- 1 Revised Table of Contents; Deleted Notice to Bidder No. 5750; Revised Wage Rates; Revised or Added Plan Sheet Nos. 1, 2, 6051, 6055, 6056, 6059, 6061, 6062, 6065, 6301, 6303-6306, 6314, 6316, 6352, 6358, 6359, 6362, 6363 & 6366; Amendment EBSx Download Required.

PROJECT: NHPP-9432-01(002)/109562301 - Itawamba

PLAN AND PROFILE OF
PROPOSED STATE HIGHWAY
FEDERAL AID PROJECT NO. NHPP-9432-01(002)

SR 76 AT SR 23 - RESTRICTED CROSSING U-TURN
ITAWAMBA COUNTY

SHEET NUMBER
6051

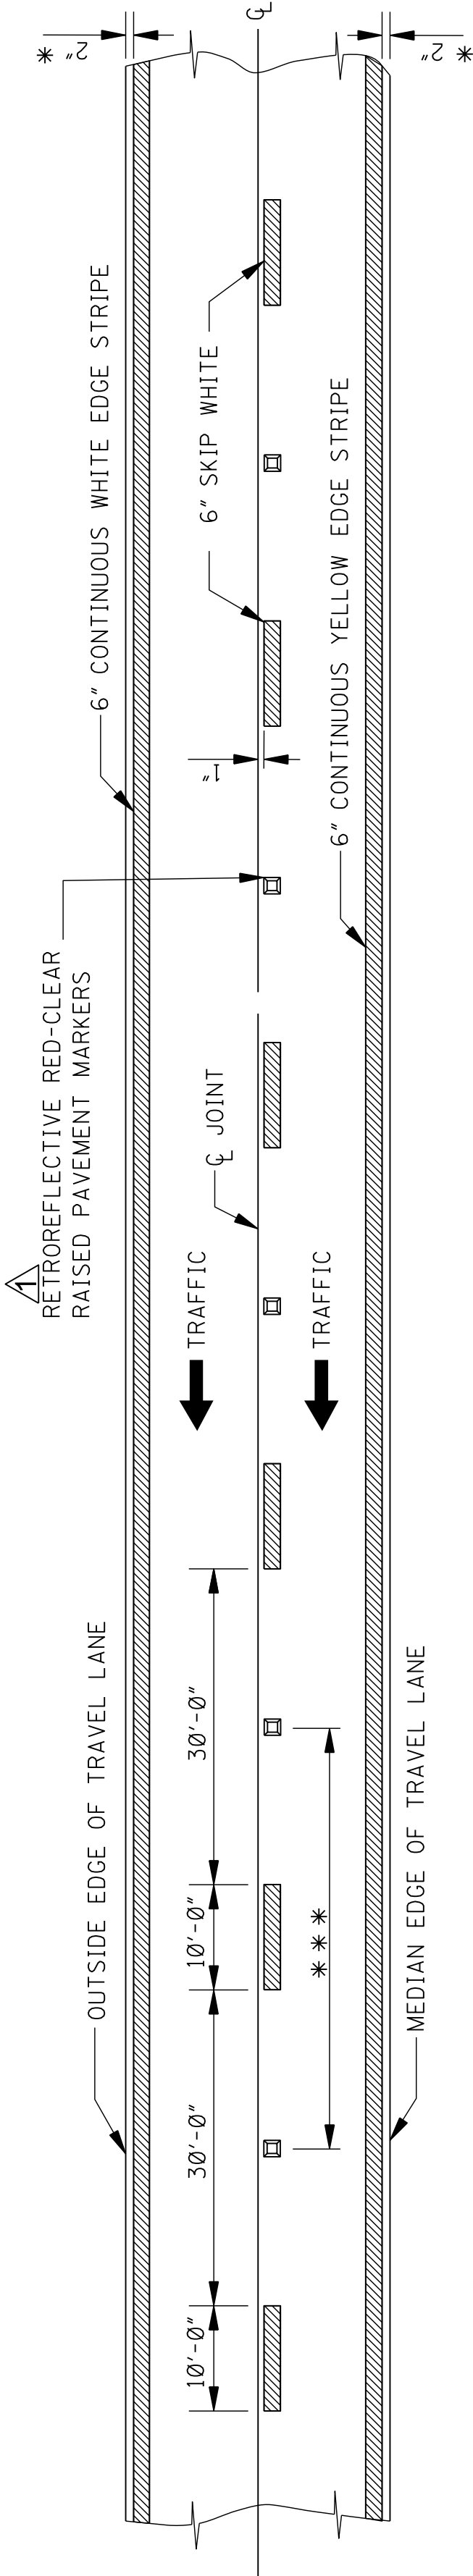
REVISION
REVISE R.P.M.S. AND TEXT

SHEET NUMBER
6352

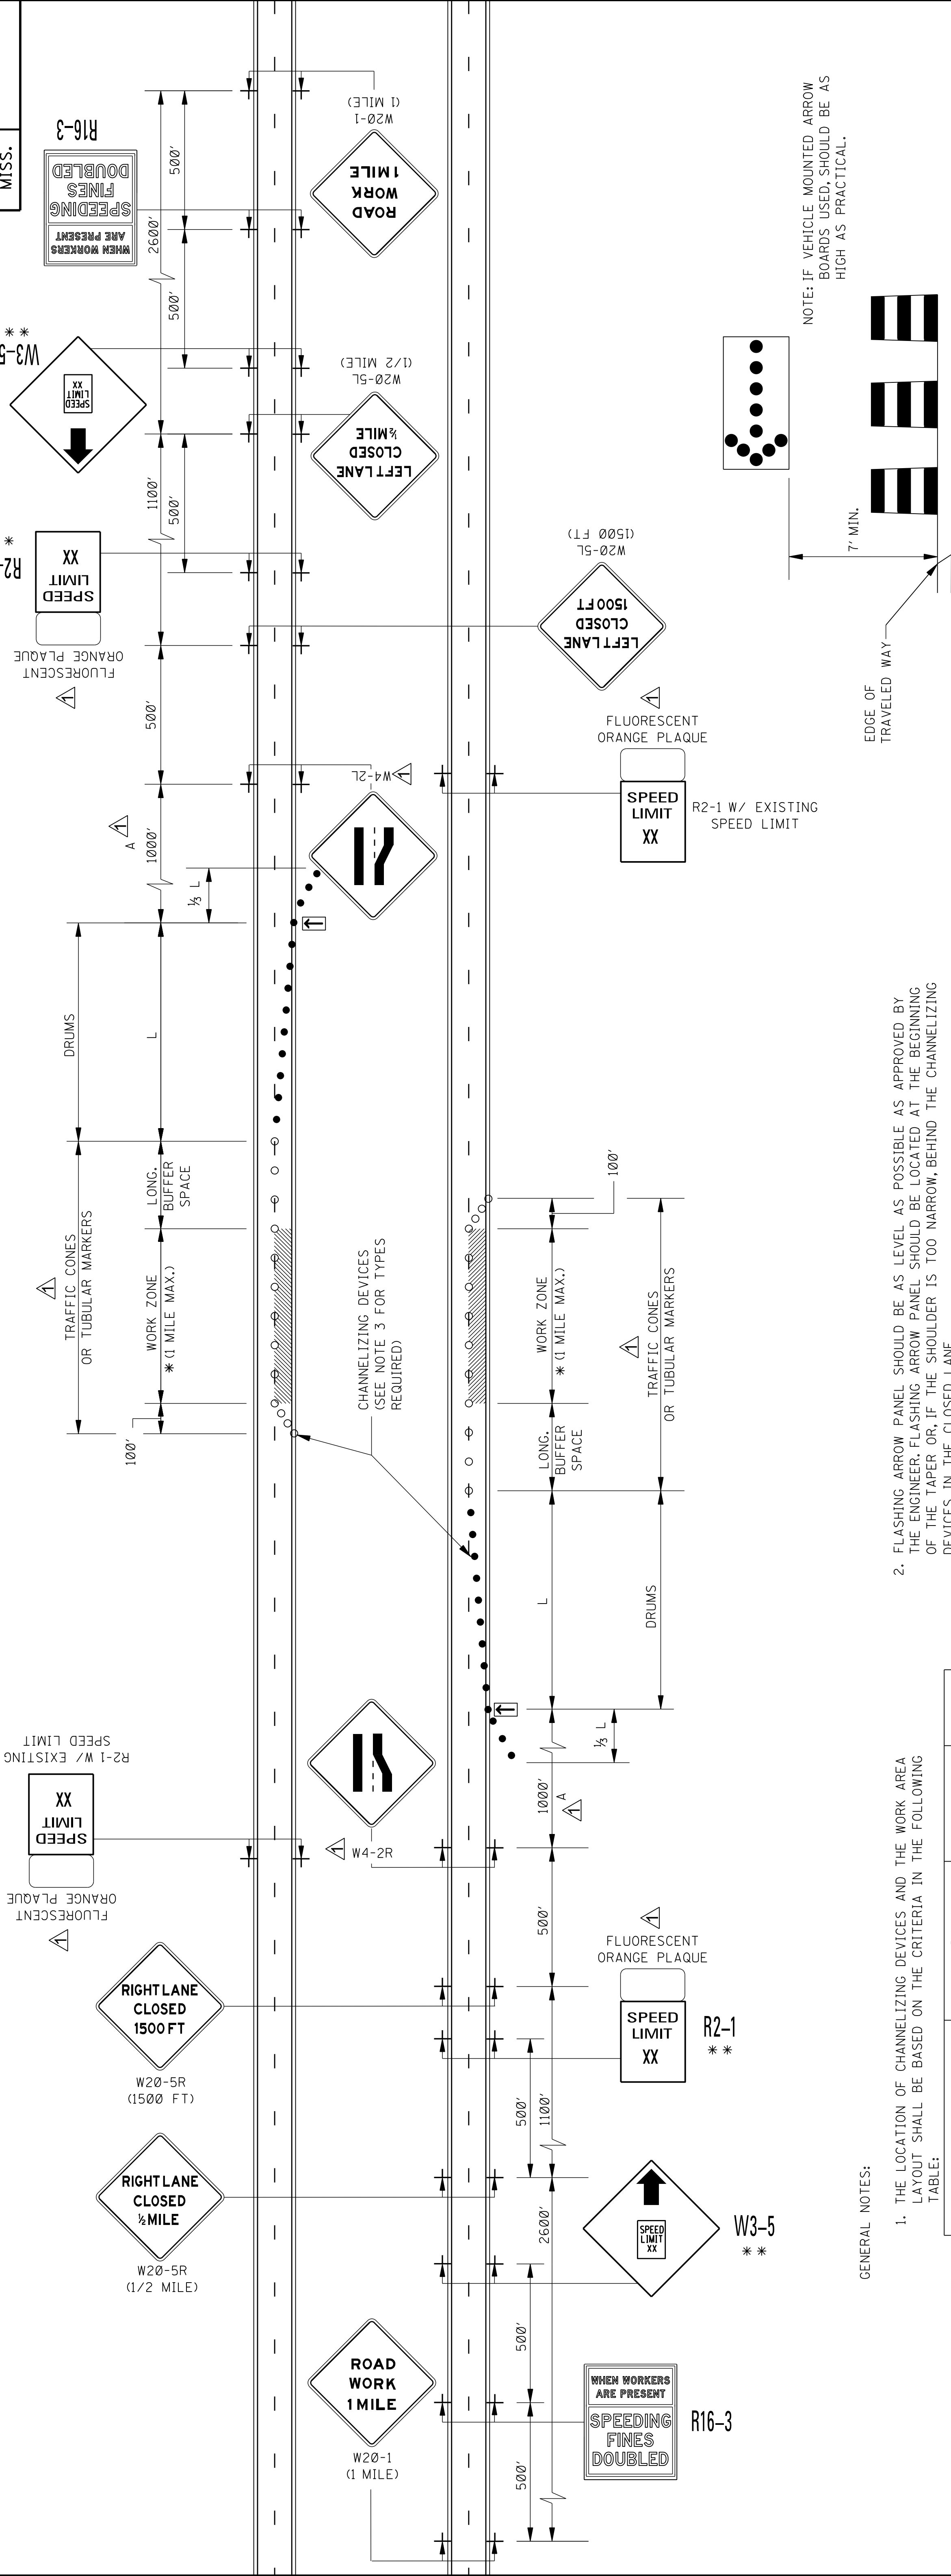
REVISION
REVISE TEXT
